TWEED VALLEY HOSPITAL NSW

ARCHITECTURAL AND URBAN DESIGN RESPONSE TO
EIS / SSD STAGE 2 APPLICATION SUBMISSIONS

26 FEBRUARY 2020

Fig. 01 Covered walkway location

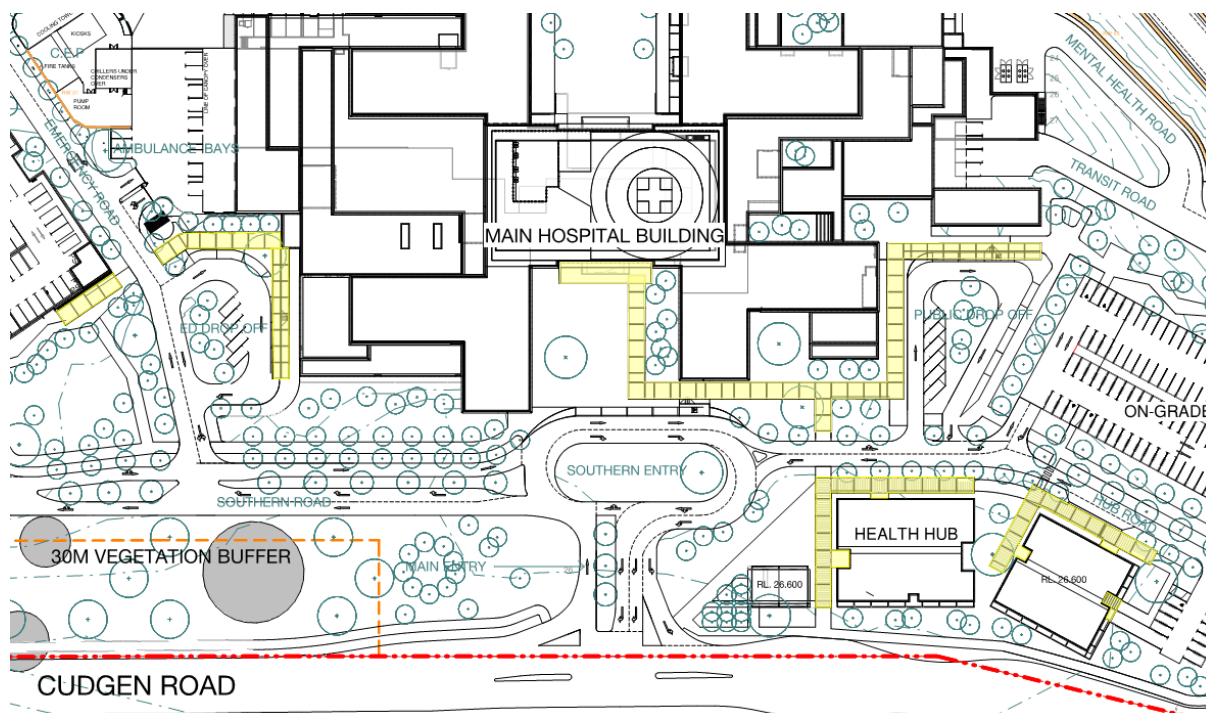
- a. That additional public domain areas be included within the site plan as high outdoor amenity areas of retreat and relaxation to enjoy the view and aspect.*
- b. Consider all pathways linking car parks to the main building to be covered walkways."*

- a. Please refer to Section 9.7 - Key Spaces, of the Landscape Architectural Report.
- b. Covered awning walkways are located on the primary public entry points to the building and connections to key public transport hubs. Please refer to the diagram below in Fig. 01
